Product/Process Change Notice (PCN)

PCN Number: PCN_ConDSUB_20250707

Affected Series: WR-DSUB

1. 6180xx25023

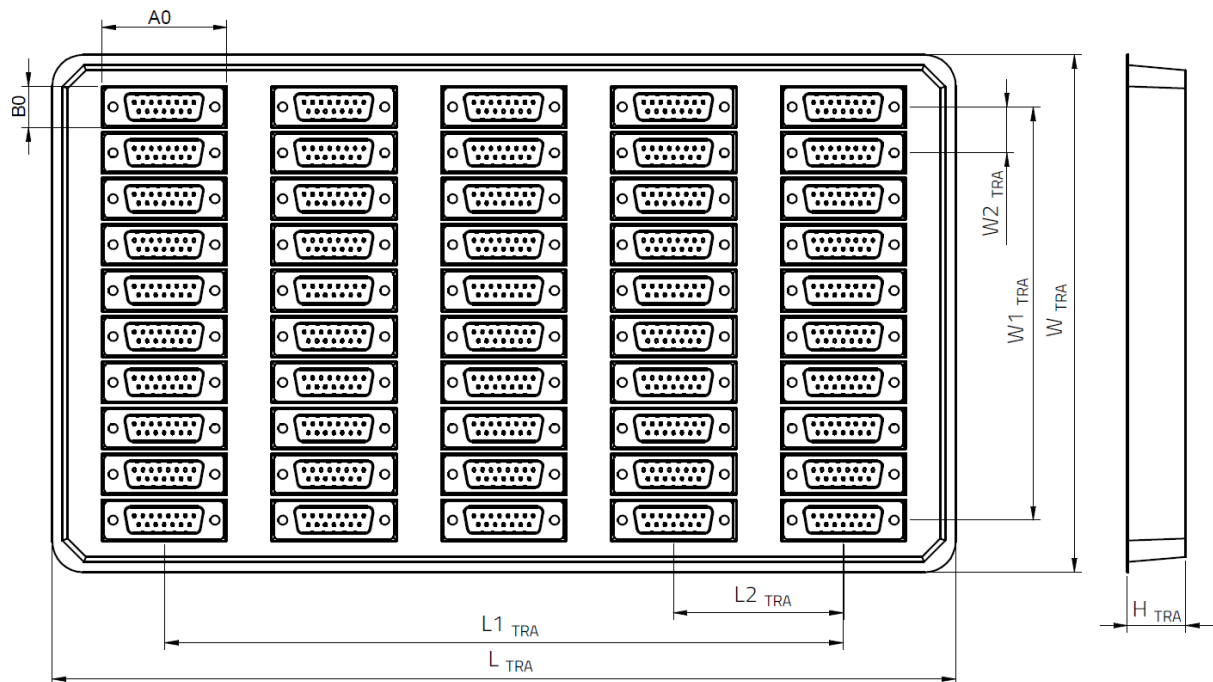
Cold-rolled shielding steel thickness:

BEFORE CHANGE	AFTER CHANGE
61800925023		
61801525023	0,30 mm	0,35 mm
61802525023		
61803725023	0,35 mm	0,40 mm

BEFORE CHANGE	AFTER CHANGE
Working Voltage	125 V (AC)	250 V (AC)
Temperature range	-40 up to +85 °C	-55 up to +105 °C
UL Approval	-	E323964

2. 6180xx25123

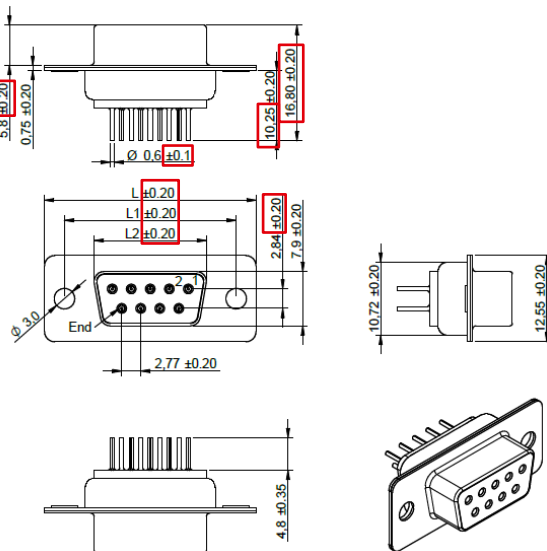
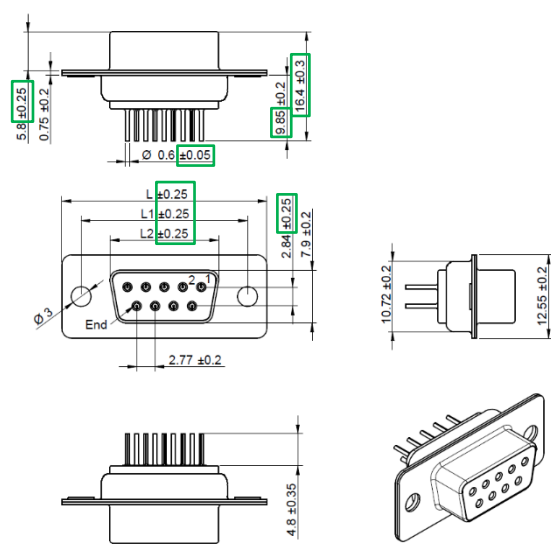
BEFORE CHANGE

AFTER CHANGE

Cold-rolled steel shielding thickness:

BEFORE CHANGE	AFTER CHANGE
61800925123		
61801525123	0,30 mm	0,35 mm
61802525123		
61803725123	0,35 mm	0,40 mm

BEFORE CHANGE	AFTER CHANGE
Working Voltage	125 V (AC)	250 V (AC)
Contact resistance	300 mΩ	30 mΩ

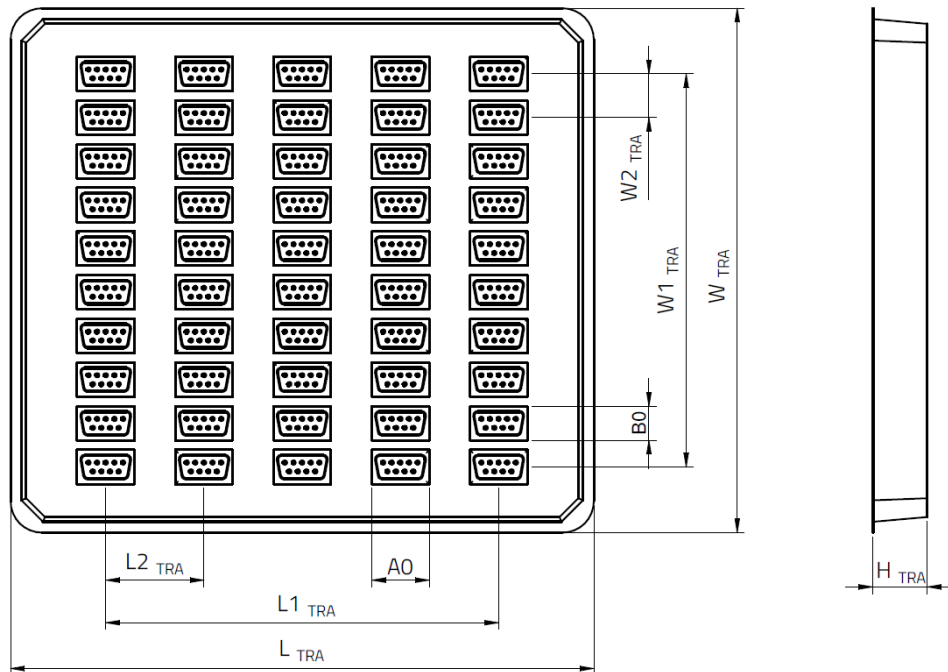
PACKAGING CHANGES

61800925023	LTRA (mm)	L1TRA (mm)	L2TRA (mm)	WTRA (mm)	W1TRA (mm)	W2TRA (mm)	HTRA (mm)	A0	B0
BEFORE CHANGE	186	122.6	30.65	174	123.3	13.7	7.4	-	-
AFTER CHANGE	187	126	31.5	168	126	14	17.5	18.5	11

61801525023	LTRA (mm)	L1TRA (mm)	L2TRA (mm)	WTRA (mm)	W1TRA (mm)	W2TRA (mm)	HTRA (mm)	A0	B0
BEFORE CHANGE	234	164	41	168	126	14	7.4	-	-
AFTER CHANGE	232	164	41	168	126	14	17.5	27	11

61802525023	LTRA (mm)	L1TRA (mm)	L2TRA (mm)	WTRA (mm)	W1TRA (mm)	W2TRA (mm)	HTRA (mm)	A0	B0
BEFORE CHANGE	297	216	54	174	130.5	14.5	7.4	-	-
AFTER CHANGE	297	214	53.5	168	126	14	17.5	41	11

61803725023	LTRA (mm)	L1TRA (mm)	L2TRA (mm)	WTRA (mm)	W1TRA (mm)	W2TRA (mm)	HTRA (mm)	A0	B0
BEFORE CHANGE	298	208.5	69.5	171	130.5	14.5	7.4	-	-
AFTER CHANGE	297	210	70	168	126	14	17.5	57.5	11

3. 6180xx29221

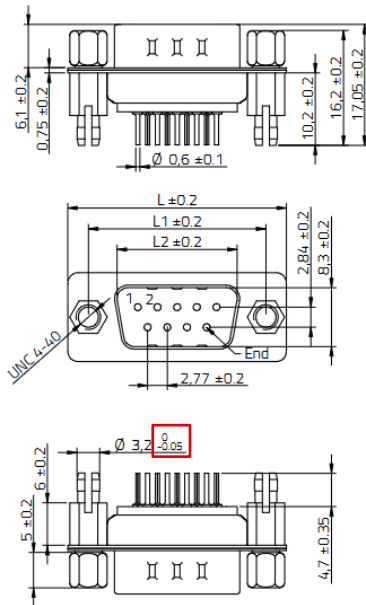
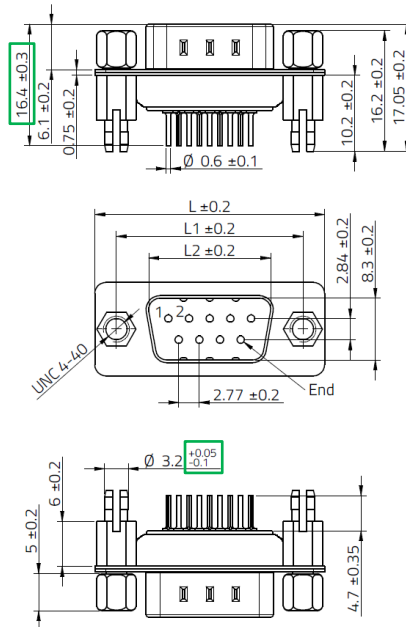
BEFORE CHANGE

AFTER CHANGE

Cold-rolled steel shielding thickness:

BEFORE CHANGE	AFTER CHANGE
61800929221		
61801529221	0,30 mm	0,35 mm
61802529221		
61803729221	0,35 mm	0,40 mm

BEFORE CHANGE	AFTER CHANGE
Working Voltage	125 V (AC)	250 V (AC)
Temperature range	-40 up to +85 °C	-55 up to +105 °C

Tray specifications :

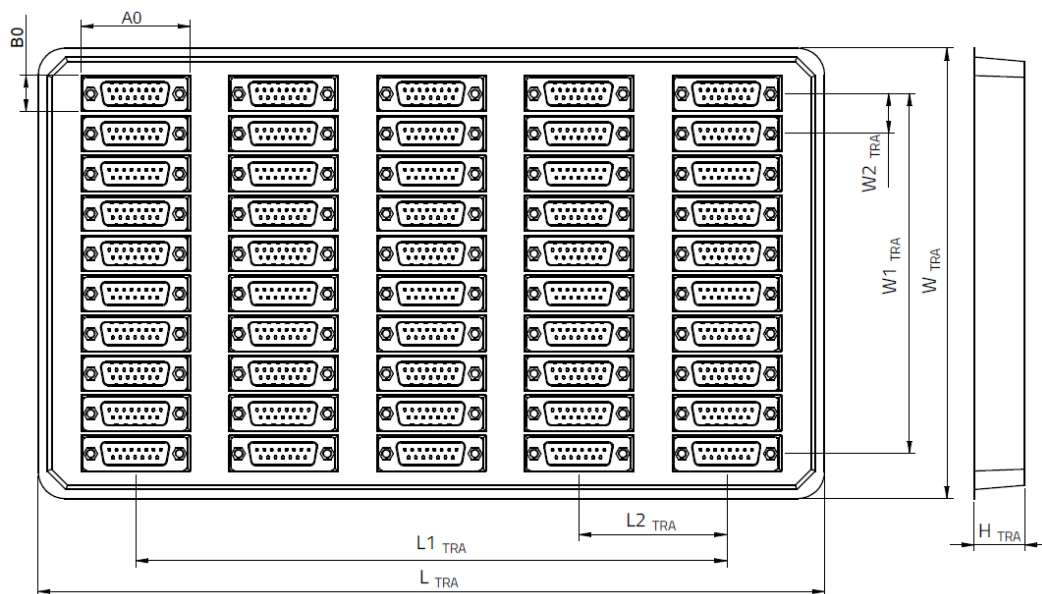
61800929221	L TRA (mm)	L1 TRA (mm)	L2 TRA (mm)	W TRA (mm)	W1 TRA (mm)	W2 TRA (mm)	H TRA (mm)	A0	B0
BEFORE CHANGE	295	214	53.5	172	128.2	14.5	17	-	-
AFTER CHANGE	295	221.8	55.5	169	135	15	19	32.4	13.4

61801529221	L TRA (mm)	L1 TRA (mm)	L2 TRA (mm)	W TRA (mm)	W1 TRA (mm)	W2 TRA (mm)	H TRA (mm)	A0	B0
BEFORE CHANGE	295	214	53.5	172	128.2	14.5	17	-	-
AFTER CHANGE	295	221.8	55.5	169	135	15	19	40.9	13.4

61802529221	L TRA (mm)	L1 TRA (mm)	L2 TRA (mm)	W TRA (mm)	W1 TRA (mm)	W2 TRA (mm)	H TRA (mm)	A0	B0
BEFORE CHANGE	310	221	73	168	128.2	14.5	17	-	-
AFTER CHANGE	295	193.4	64.5	169	135	15	19	53.7	13.4

4. 6180xx29321

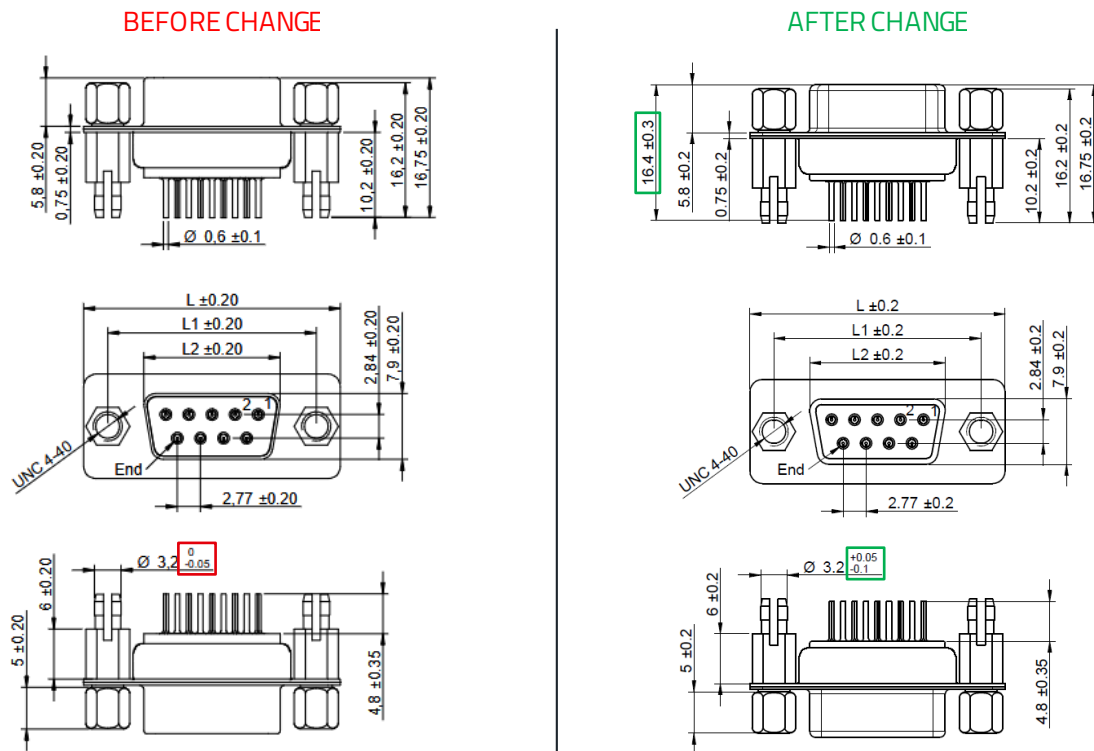
Cold-rolled steel shielding thickness:

BEFORE CHANGE	AFTER CHANGE
61800929321		
61801529321	0,30 mm	0,35 mm
61802529321		
61803729321	0,35 mm	0,40 mm

BEFORE CHANGE	AFTER CHANGE
Working Voltage	125 V (AC)	250 V (AC)
Temperature range	-40 up to +85 °C	-55 up to +105 °C

Tray specifications :

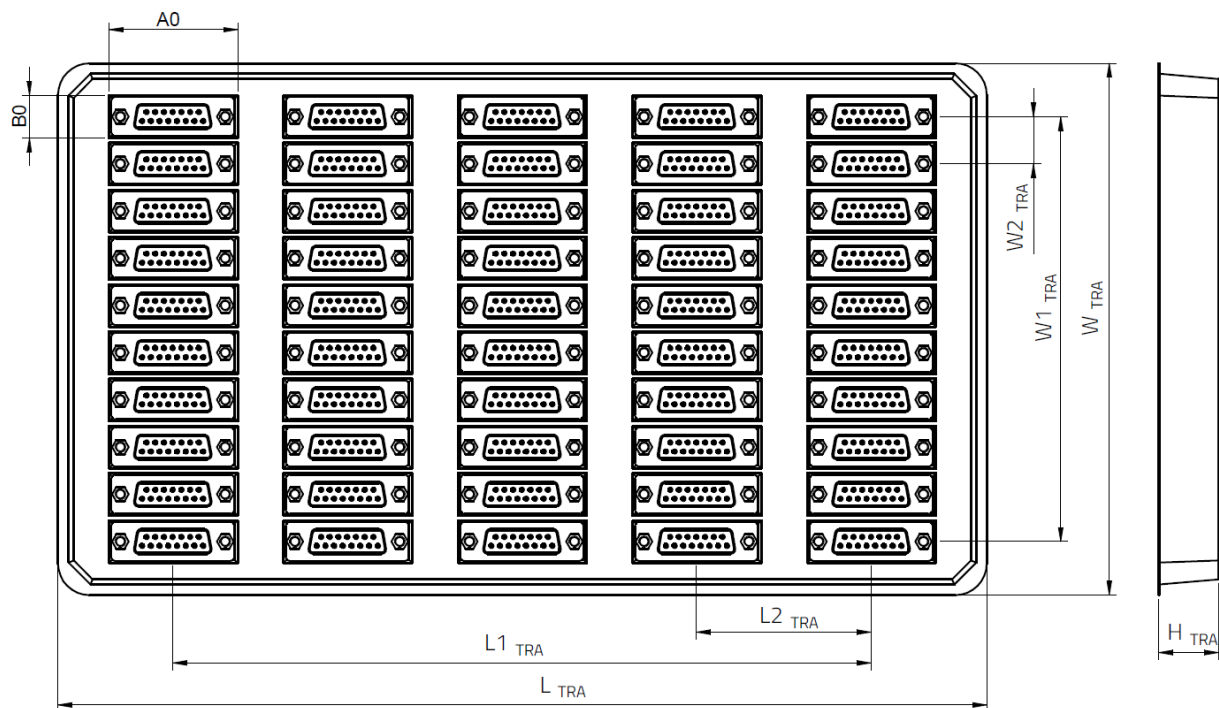
61800929321	L TRA (mm)	L1 TRA (mm)	L2 TRA (mm)	W TRA (mm)	W1 TRA (mm)	W2 TRA (mm)	H TRA (mm)	A0	B0
BEFORE CHANGE	168	122.6	30.65	174	123.3	13.7	7.4	-	-
AFTER CHANGE	295	221.8	55.5	169	135	15	19	32.4	13.4

61801529321	L TRA (mm)	L1 TRA (mm)	L2 TRA (mm)	W TRA (mm)	W1 TRA (mm)	W2 TRA (mm)	H TRA (mm)	A0	B0
BEFORE CHANGE	234	164	41	168	126	14	7.4	-	-
AFTER CHANGE	295	221.8	55.5	169	135	15	19	40.9	13.4

61802529321	L TRA (mm)	L1 TRA (mm)	L2 TRA (mm)	W TRA (mm)	W1 TRA (mm)	W2 TRA (mm)	H TRA (mm)	A0	B0
BEFORE CHANGE	297	216	54	170	130.5	14.5	7.4	-	-
AFTER CHANGE	295	193.4	64.5	169	135	15	19	53.7	13.4

61803729321	LTRA (mm)	L1TRA (mm)	WTRA (mm)	W1TRA (mm)	W2TRA (mm)	HTRA (mm)
BEFORE CHANGE	298	208.5	171	130.5	14.5	7.4
AFTER CHANGE	311	283	228	188.1	20.9	19
